FIELD CHANGE ORDER	NUMBER: CI780-I007
--------------------	--------------------

APPLICABILITY: When installing a 9XXX or 65XX system with a CIXCD or when upgrading an existing cluster with a CIXCD, replace ALL L0100 Rev "D" modules with L0118-\*\* or L0100 Rev "E" module (if available). This FCO affects all CI750, CI780, CIBCI and HSC50/70 nodes in VAXclusters containing a CIXCD.

SOLUTION: Replace all L0100 Rev D modules when installing CIXCD.

SET L0100-E1 COMPATIBILITY JUMPER AS FOLLOWS:

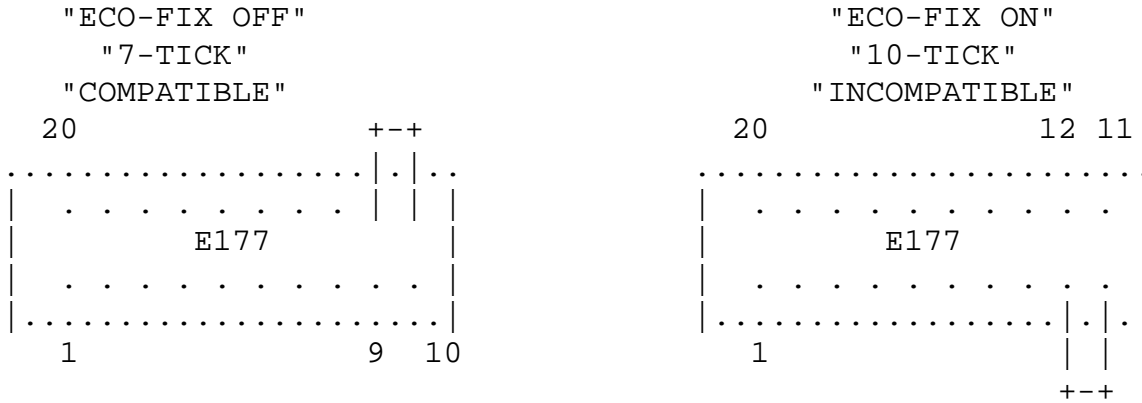
o 7/10-TICK COMPAT. MODE SET BY 1 JUMPER @ E177 stake-pins.

- "7-TICK COMPAT.-MODE": jumper E177-11 to E177-12
- "10-TICK INCOMPAT.-MODE": jumper E177-9 to E177-10

o L0100-E1 QUICK-CHECK (PART-REVISION VERIFY):

- ECO wires at E177-13 and E177-9.
- STAKE-PINS (for jumper) @ E177-9,10,11,12.
- ETCH REV-C: P/N "50-14430C-0" marking.
